# Addendum No. 7 to Contract Documents

Project	Biosolids Process Improvements	CWSRF Project No.	C7-6240-13-00
Owner	The City of Auburn		
Contract No.	BPI-1A General BPI-1B Heating and Ventilation BPI-1C Electrical BPI-1D Plumbing	Date	January 13, 2023

**January 13, 2023**

DRAWING NUMBER  
**A-30-201**

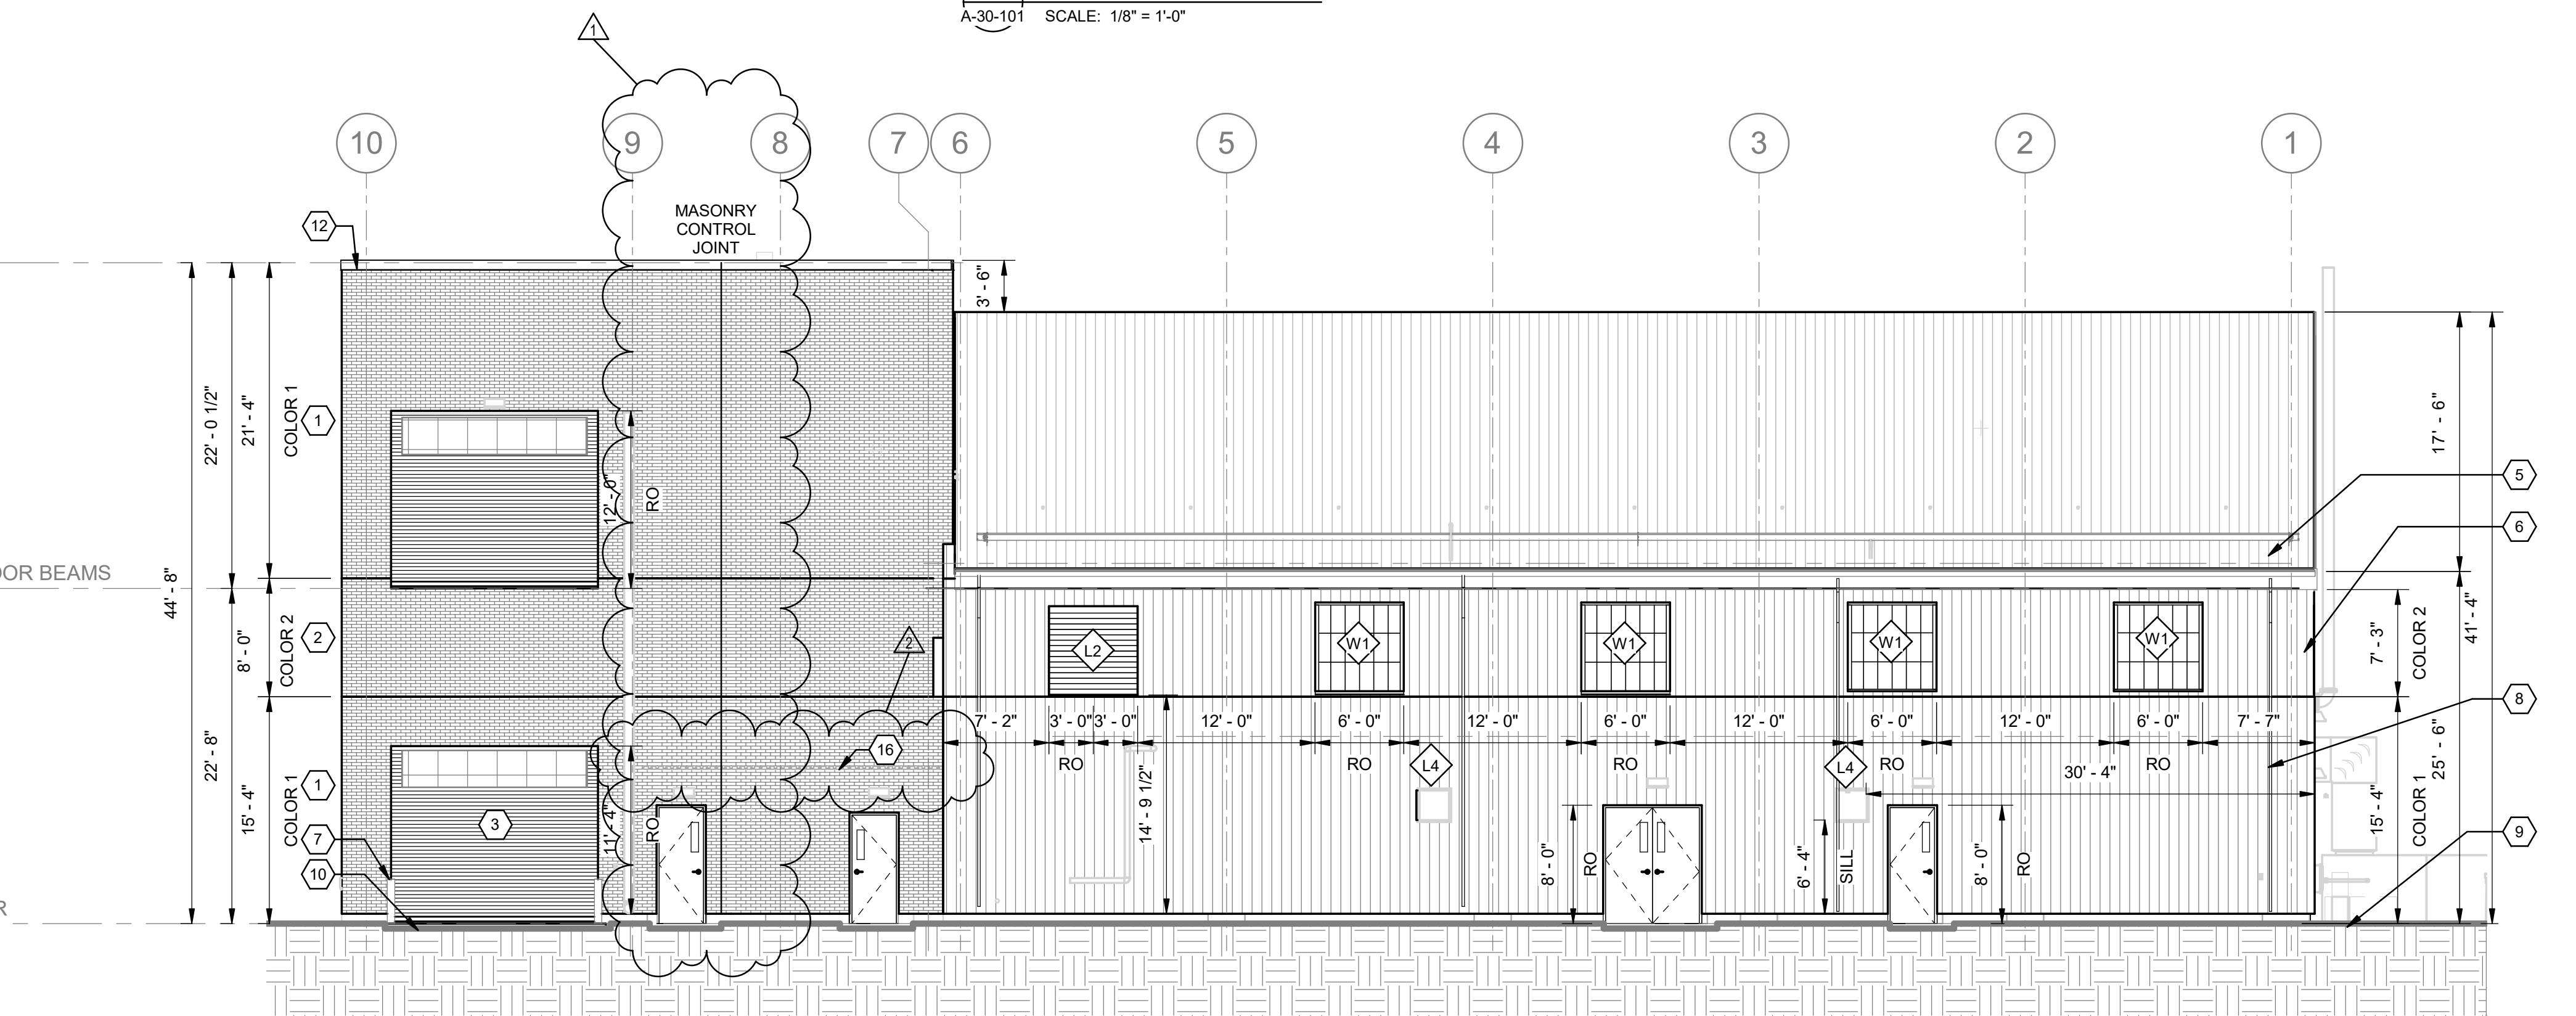
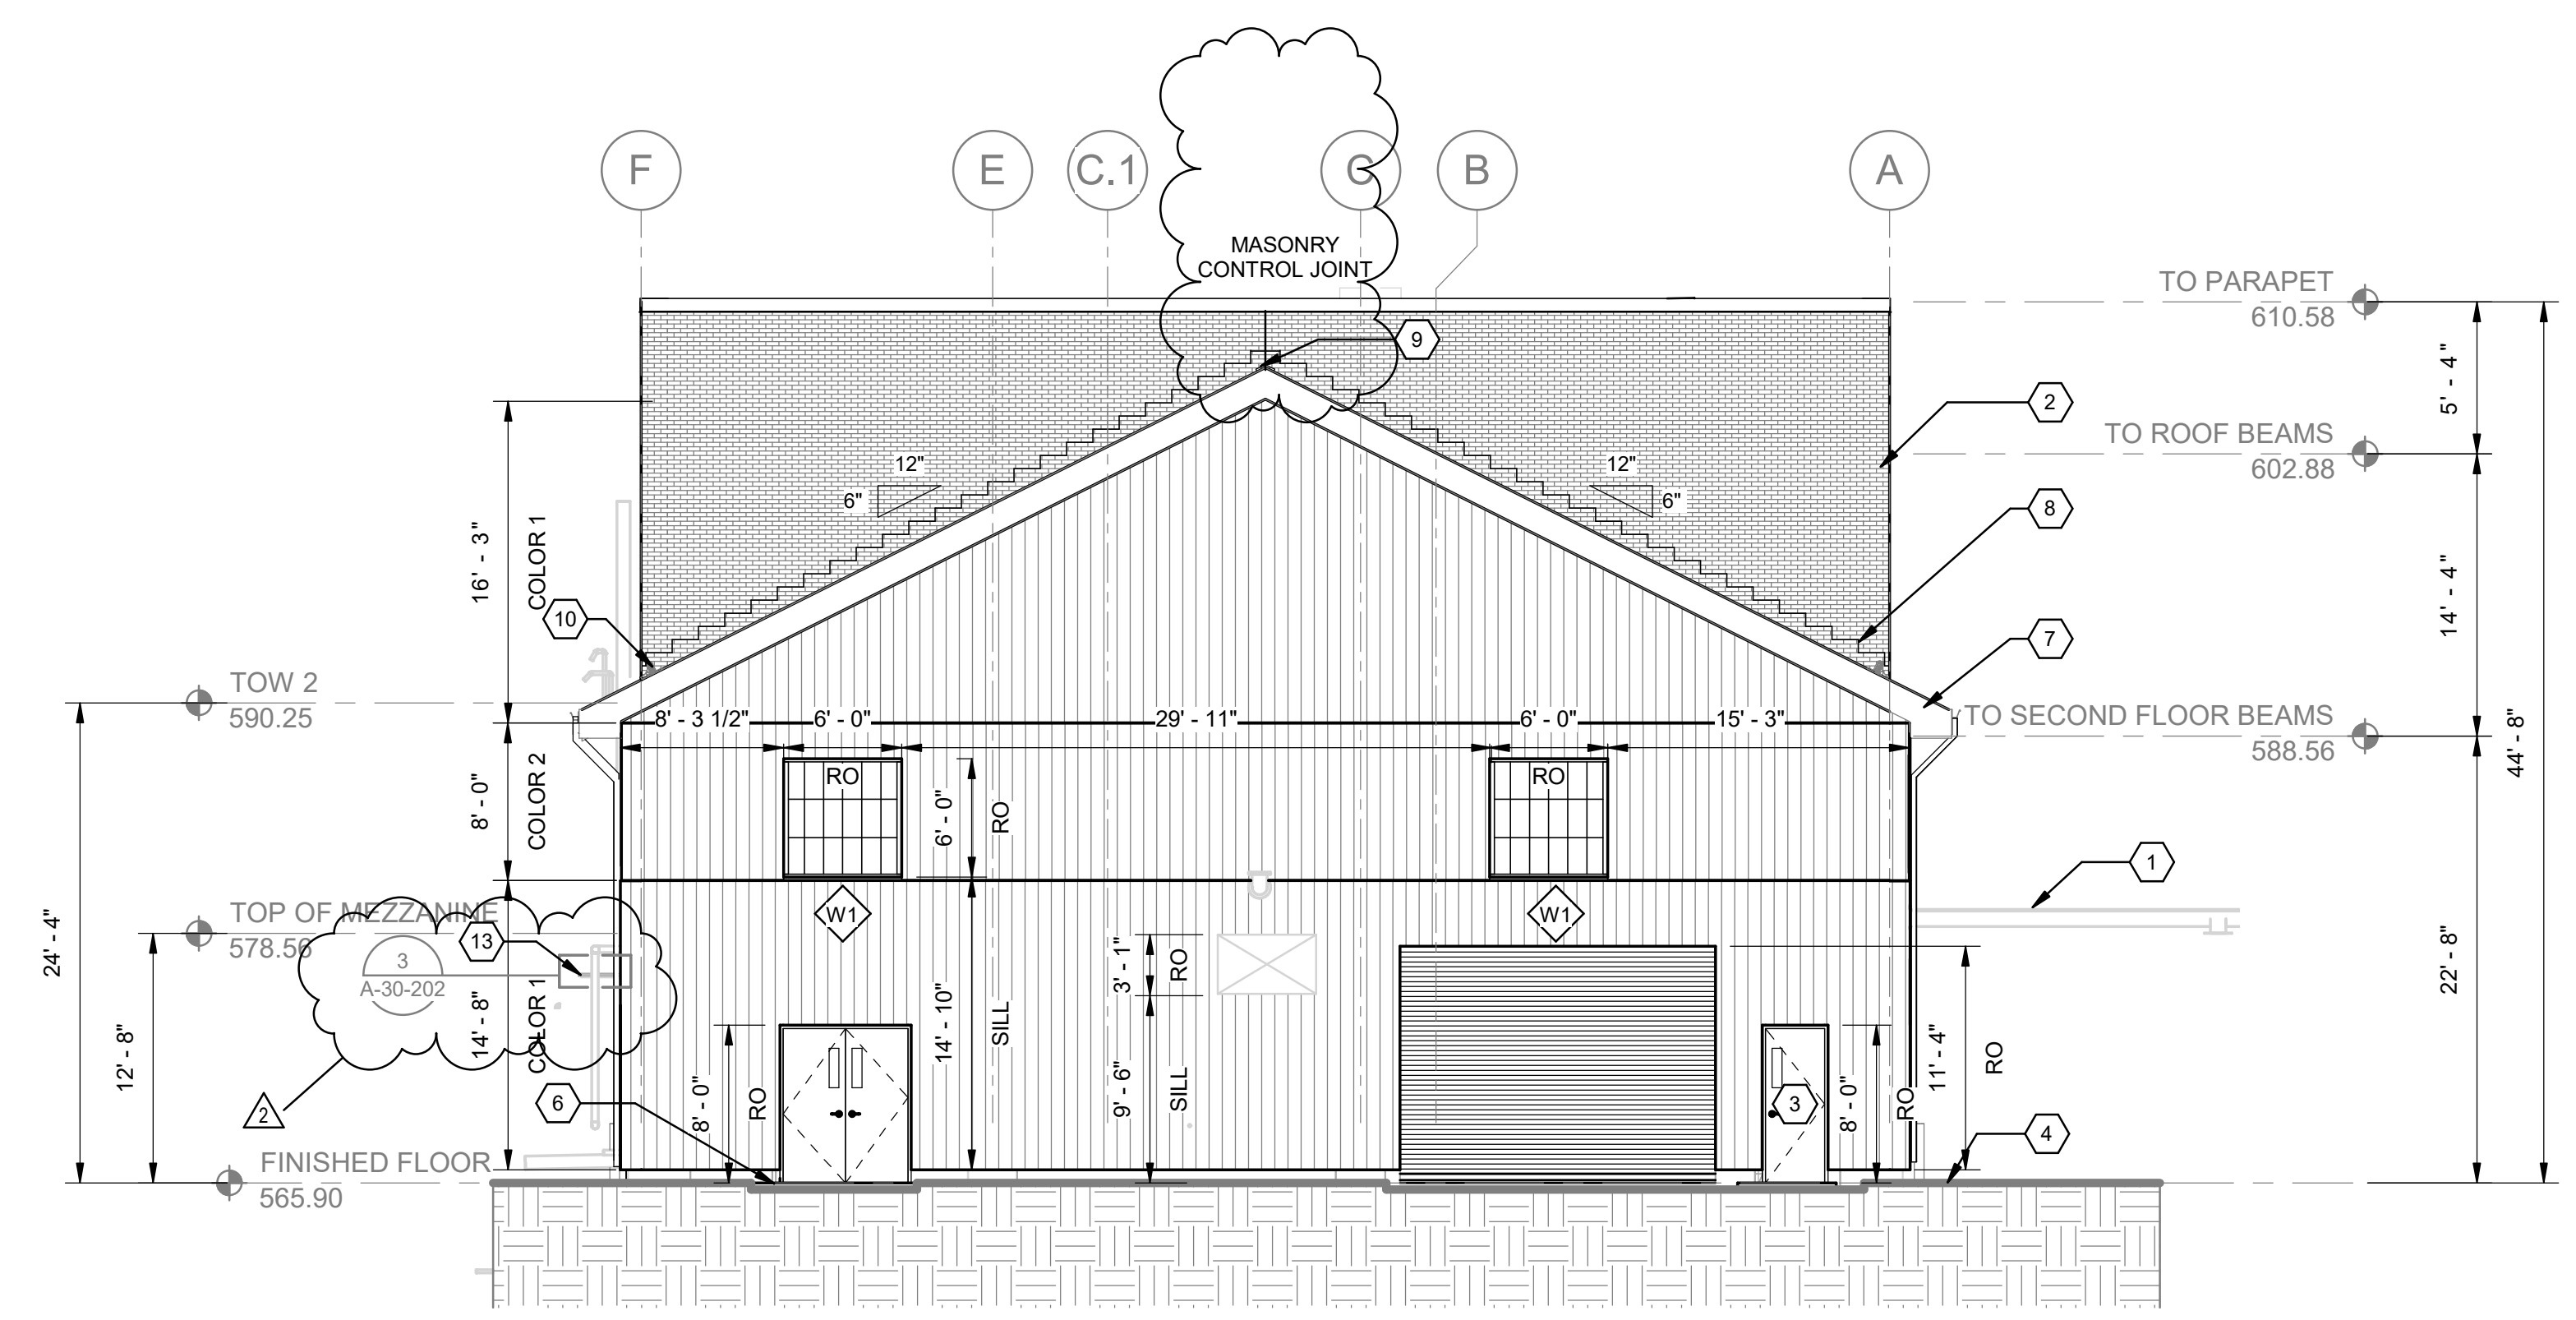
- 12 BRICK VENEER, COLOR 1 TO MATCH LIGHT TAN COLOR OF EXISTING SOLIDS HANDLING BUILDING ON SITE
  - 13 CANOPY STRUCTURE APPROXIMATELY 3'-4" WIDE X 1'-0" DEEP X 20'-0" WIDE. REFERENCE DETAIL 3 ON A-30-202. REFERENCE STRUCTURAL DRAWINGS FOR MORE INFORMATION.
